ADDENDUM NO. 1

PROJECT NAME: Nebraska Union First Floor Selective Refurbishment
UNL PROJECT NUMBER: C026P336
BID INVITATION NUMBER: 2209-13-7200

CONSULTANT: Holland Basham Architects
ADDRESS: 119 S. 49th Ave, Omaha, NE

DATE OF ISSUANCE: 20 August 2013
DATE OF BID OPENING: 27 August 2013

DEMOLITION PLAN

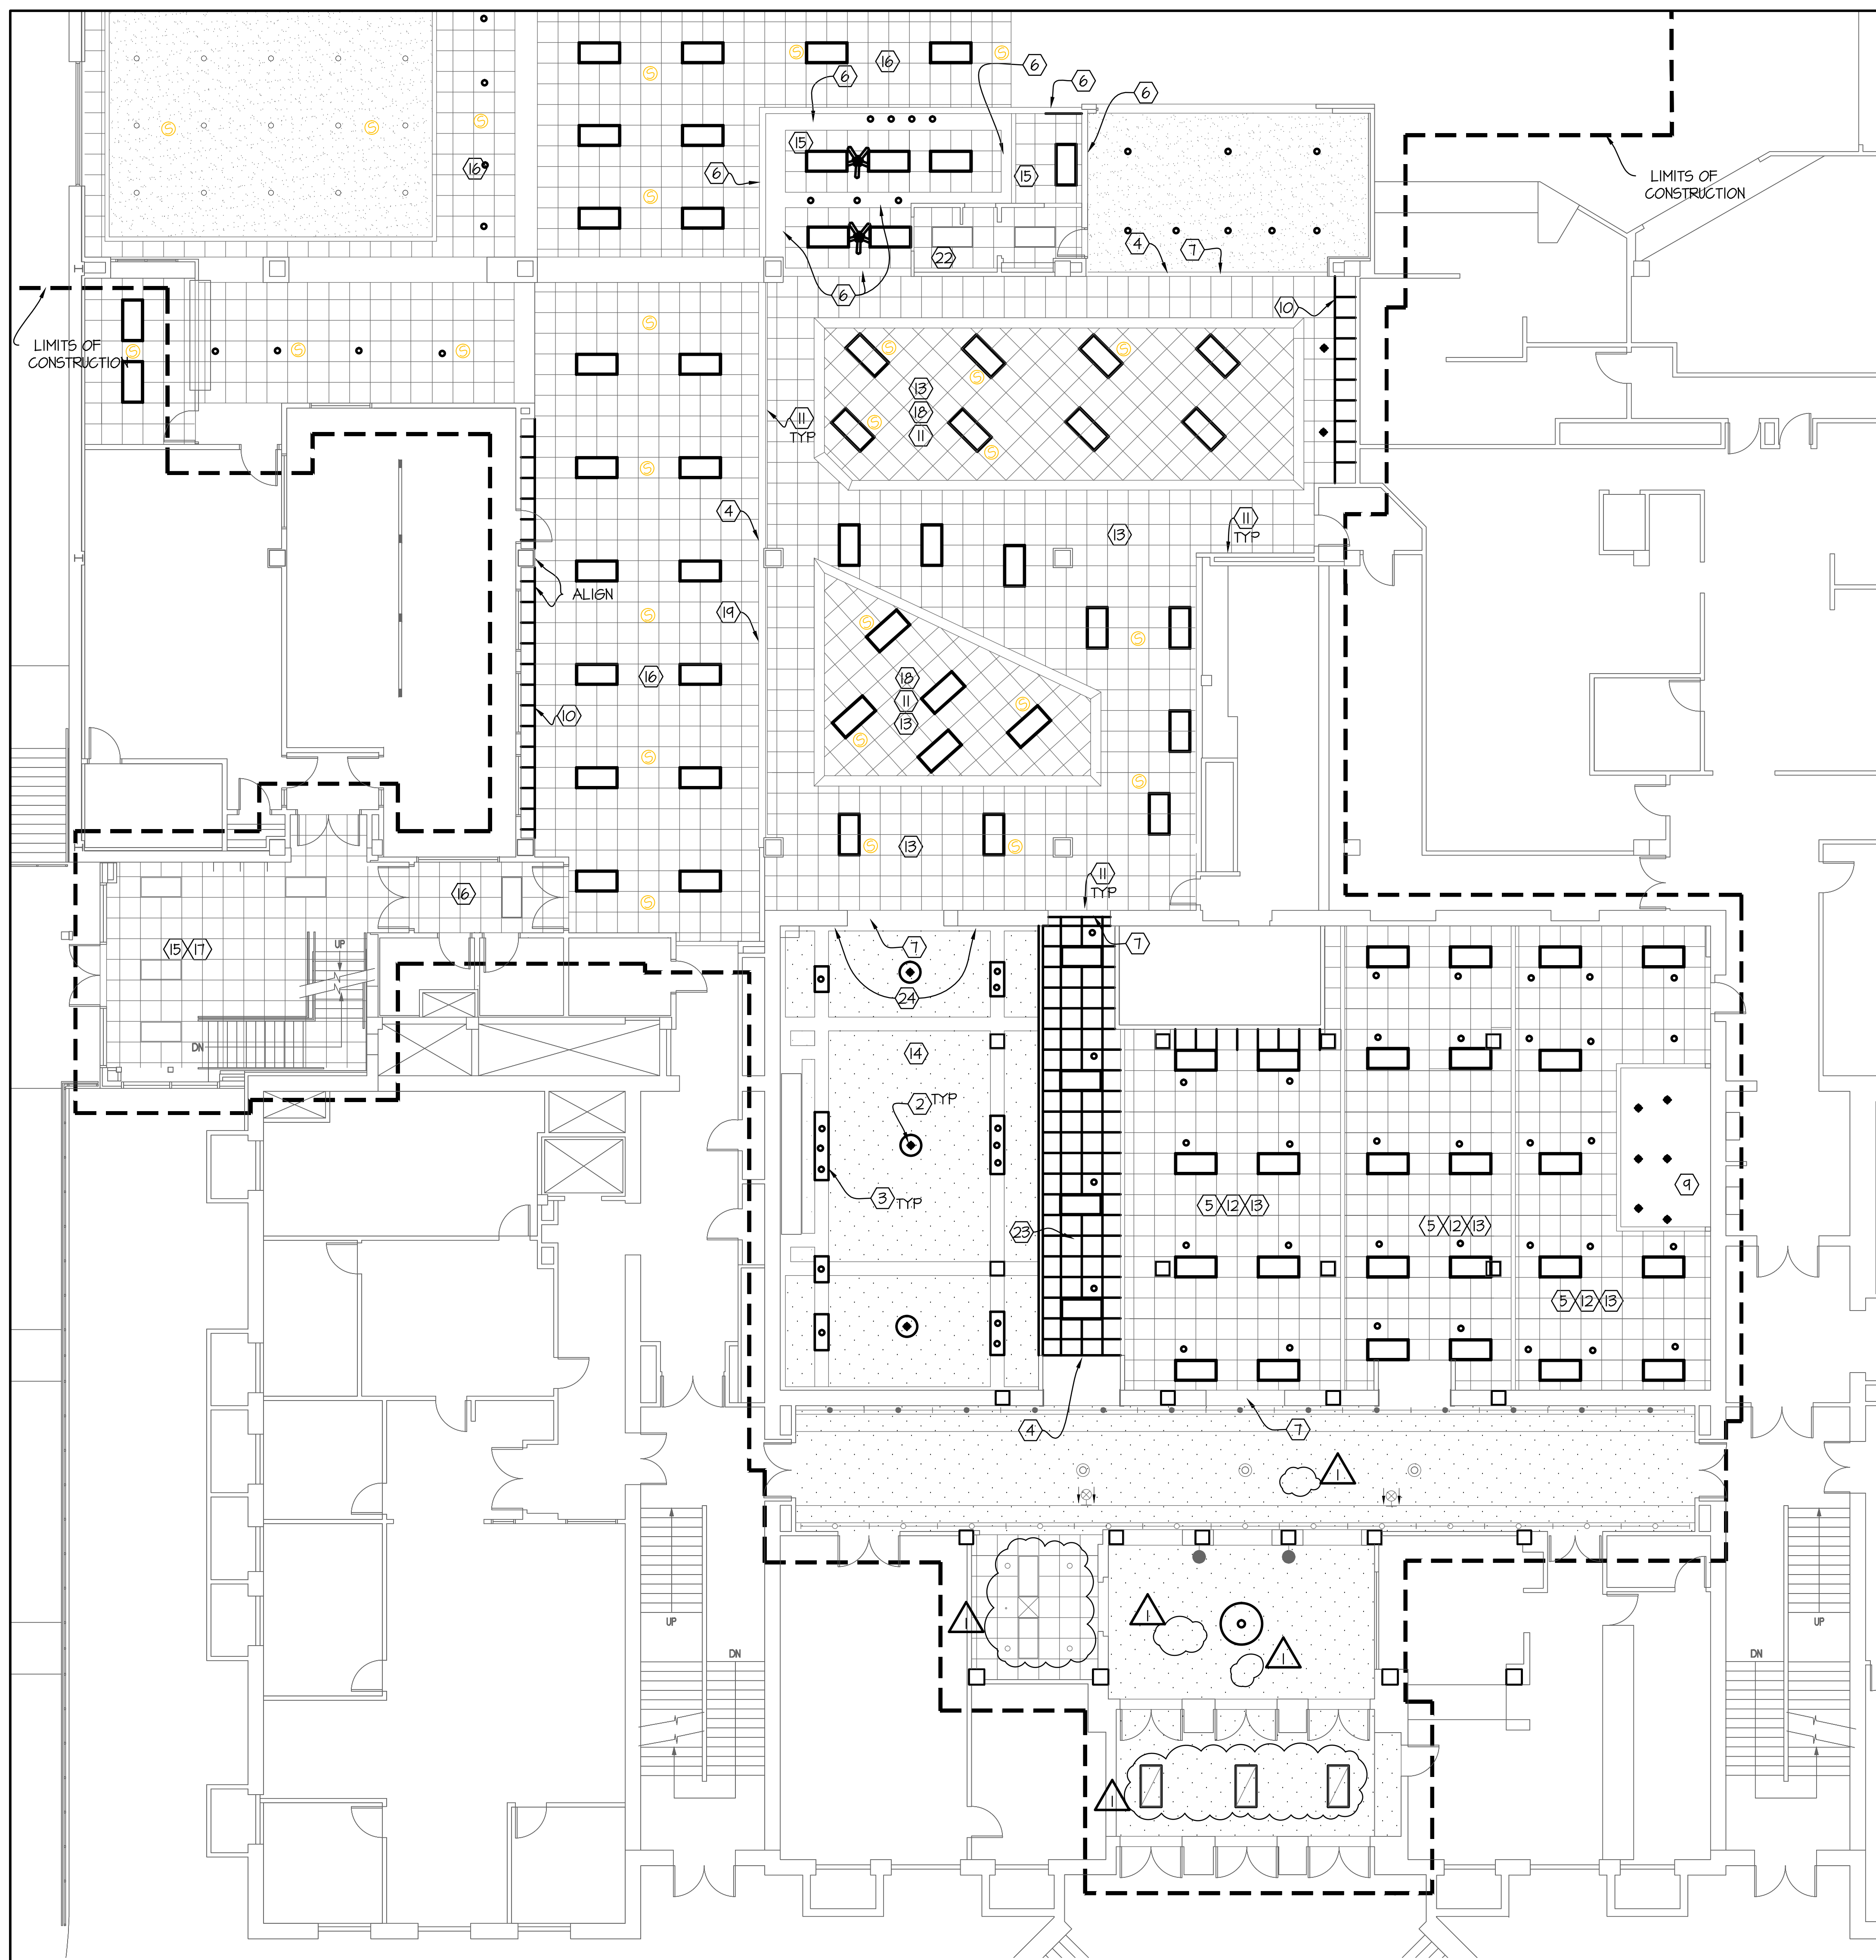
1. Delete the following keyed notes:
 - a. Keyed Demolition Notes: 6, 12, 25, 34 & 36
 - b. Corridor 126; numbers 25, 26 & 29
 - c. Lobby 128; numbers 26
 - d. Vending 128; number 2
 - e. Vestibule 129; numbers 2, 4, 6, 12, 24 & 36

**REFLECTED CEILING
DEMOLITION PLAN**

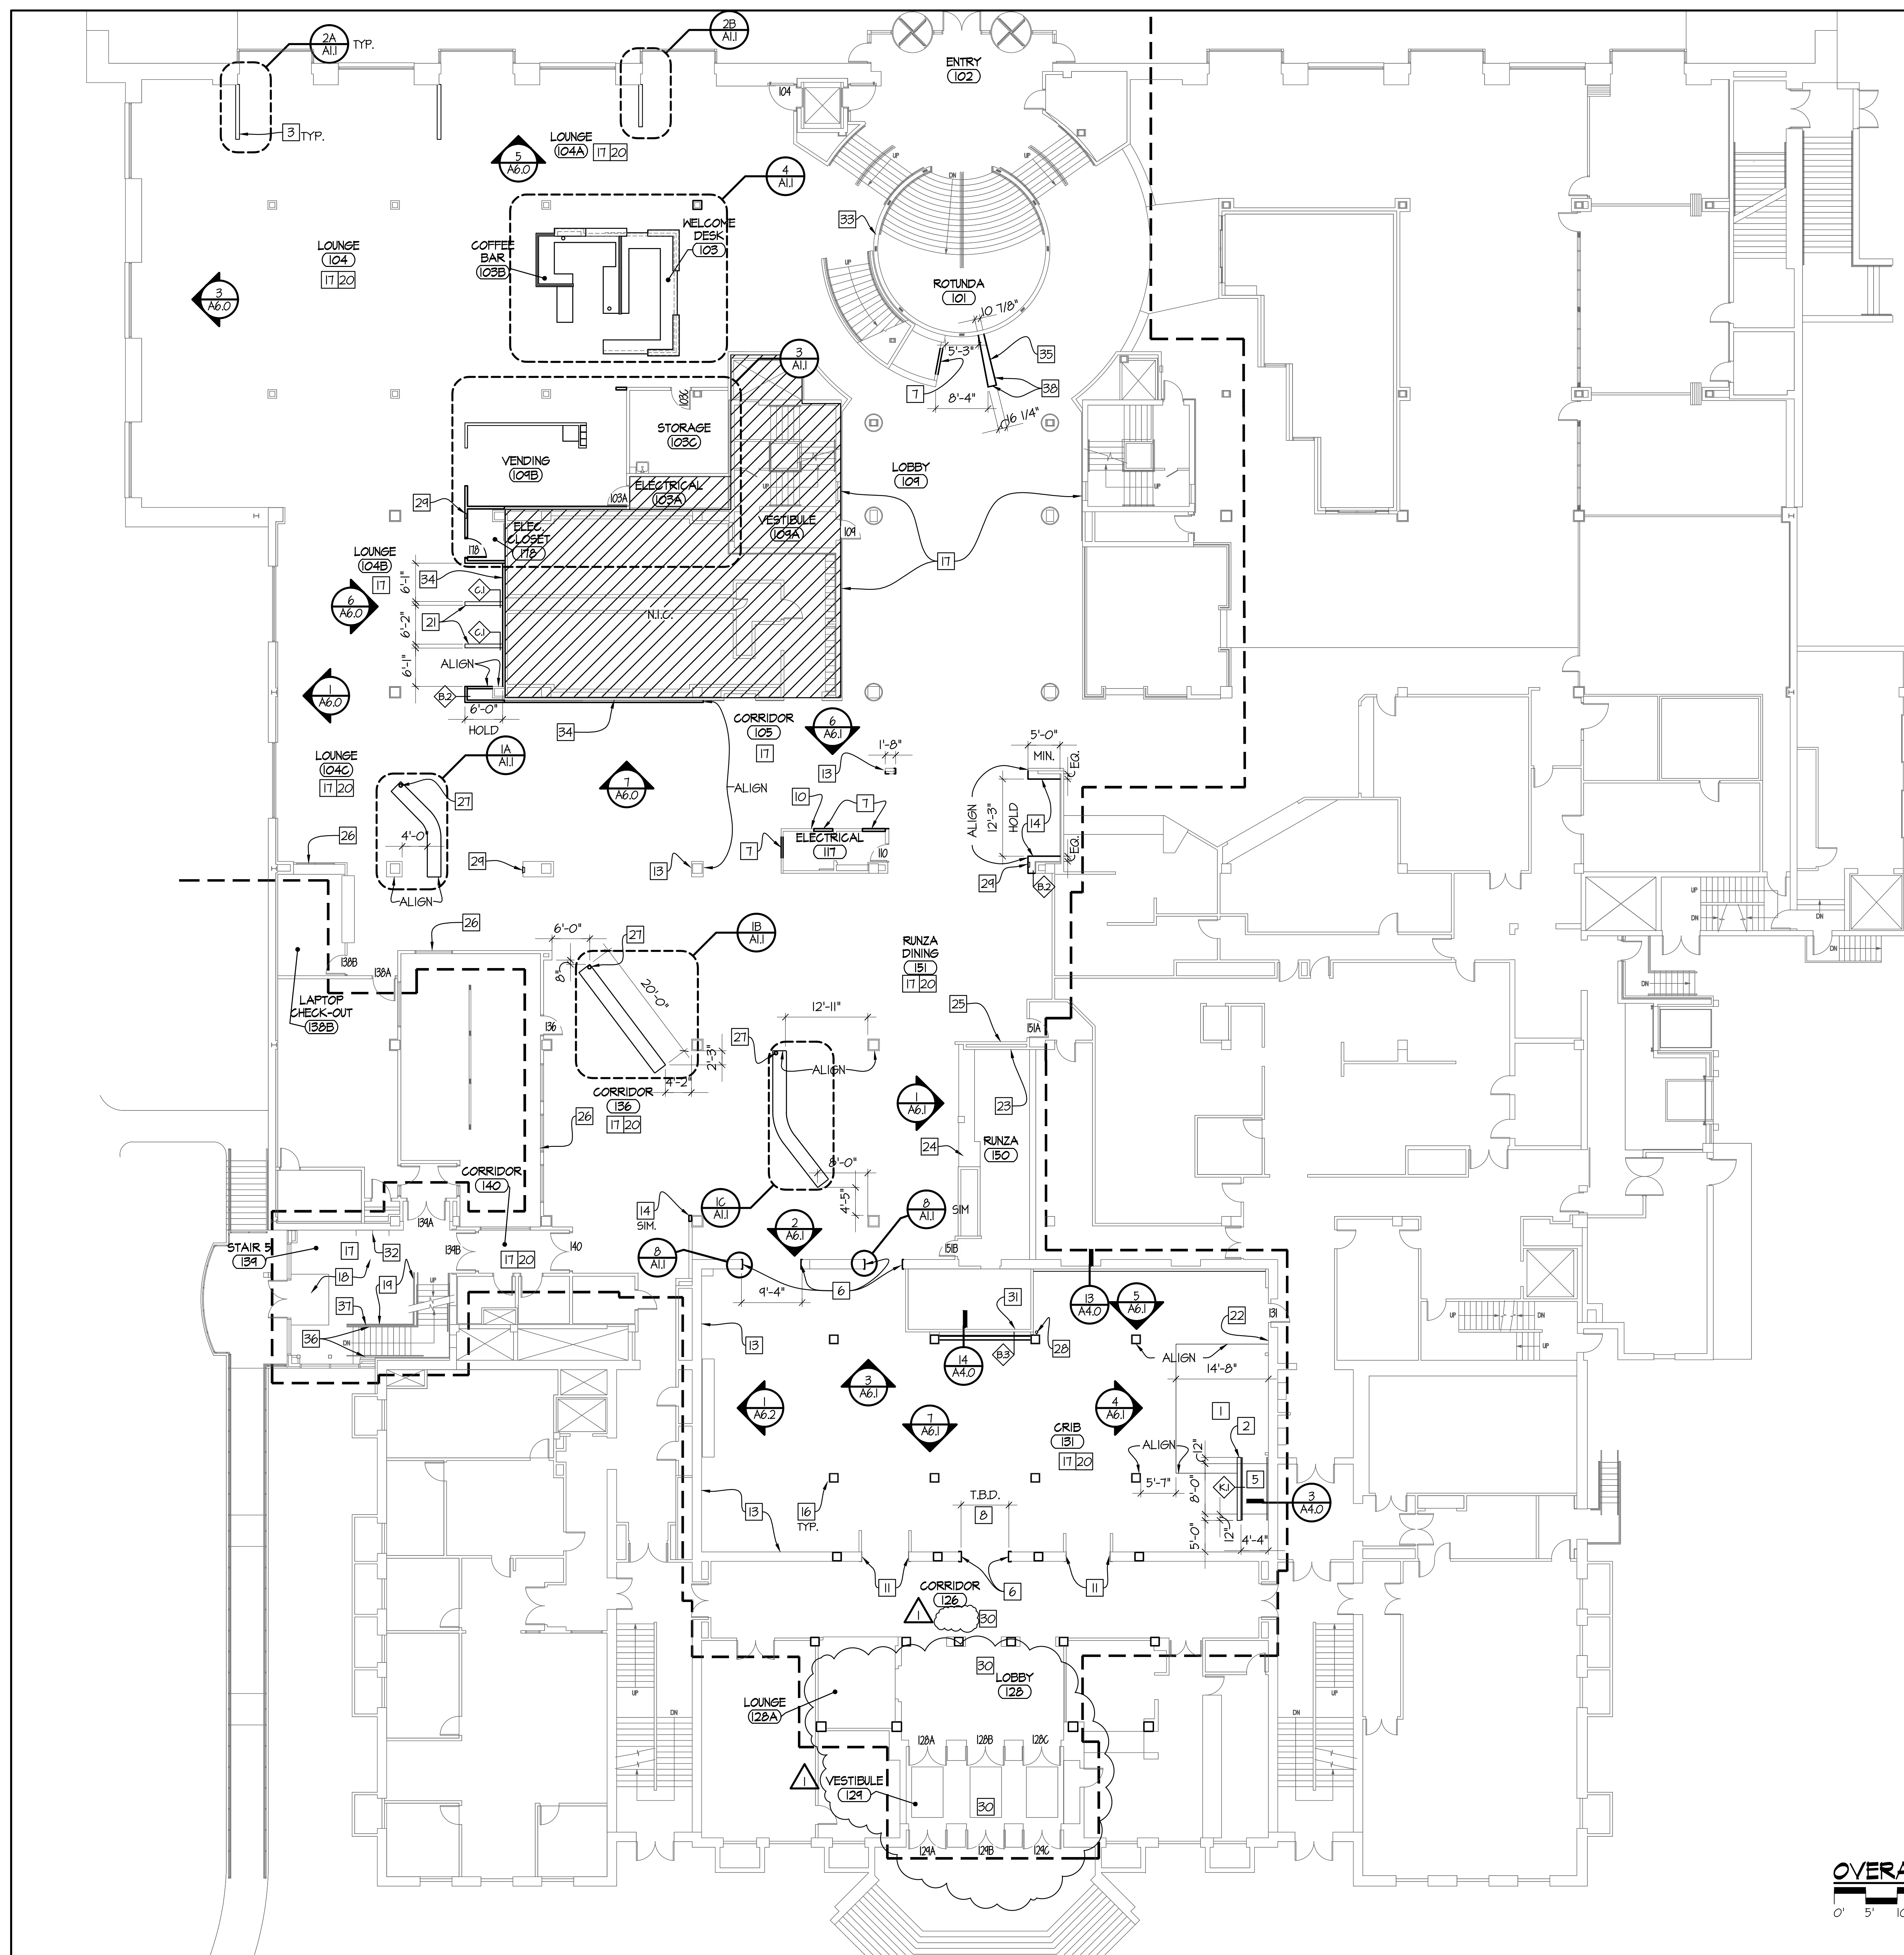
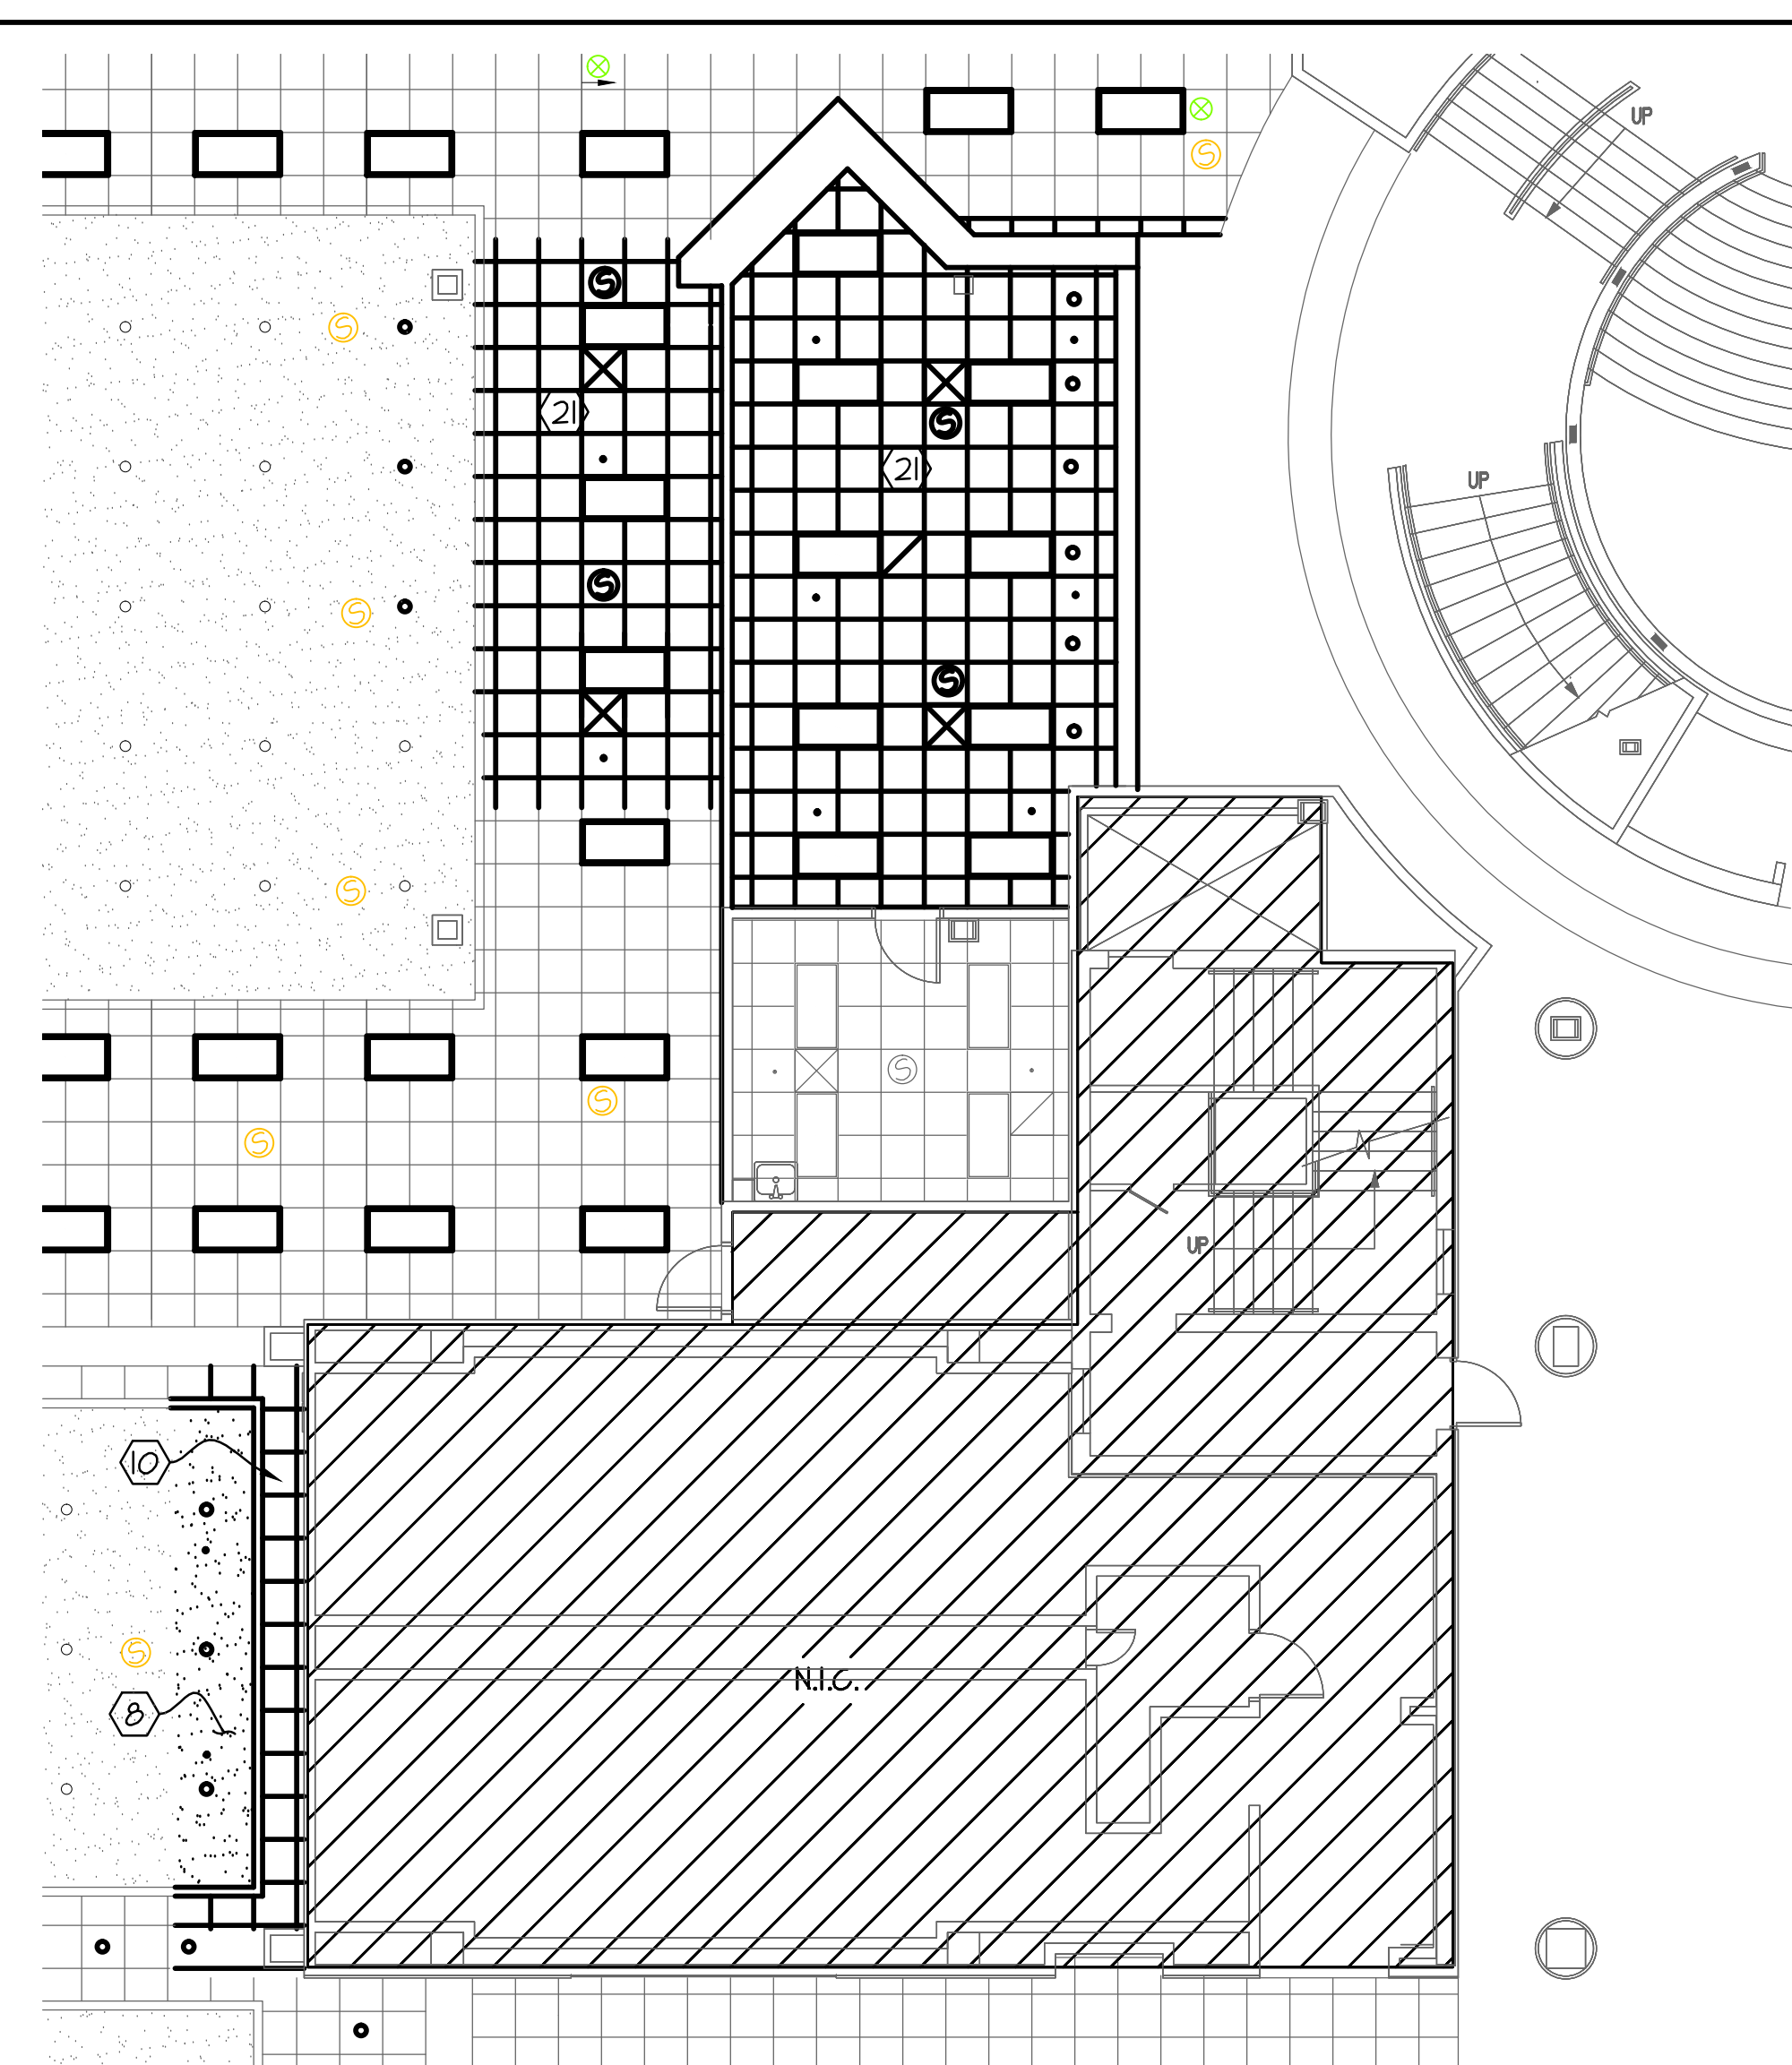
1. Delete the following keyed notes:
 - a. Corridor 126: number 14
 - b. Lobby 128: numbers 1 & 14
 - c. Vestibule 129: number 14
2. Modify lights in Vending area 128A to be shown as existing.
